Johnston "9" Federal No. 1 1980' FSL & 1980' FWL Sec 9, T19S R25E

Plug and Abandon

Permanent Abandonment of Federal Wells Conditions of Approval

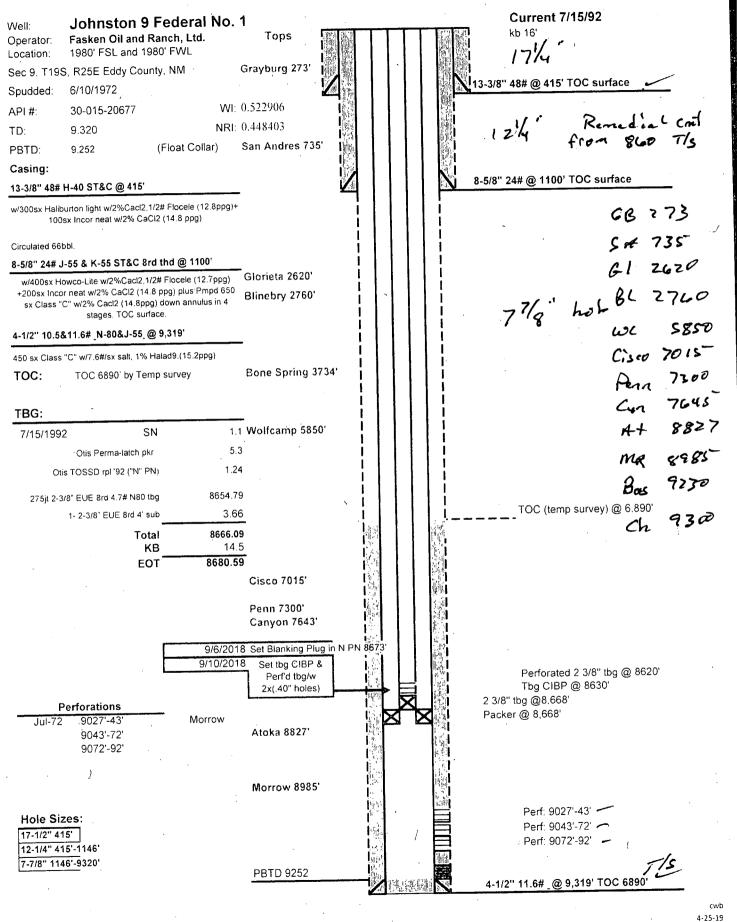
- RUWL and 3000 psi lubricator. RIW with 1-11/16" strip gun and perforate 4 squeeze holes at 3,750'. RDWL.
- 22. <u>Plug #4:</u> Open 4-1/2" x 8-5/8" casing to pit. Squeeze perfs at 3,750' with 40 sx Class "C" cement, displacing cement with 9.5 ppg gel laden mud to 3,590' or above. WOC 4 hours. Release packer, RIW with tubing and <u>TAG</u> cement plug at or above 3590' and notify Midland Office and BLM of the results.
 Add Pluce (Gloric tla)
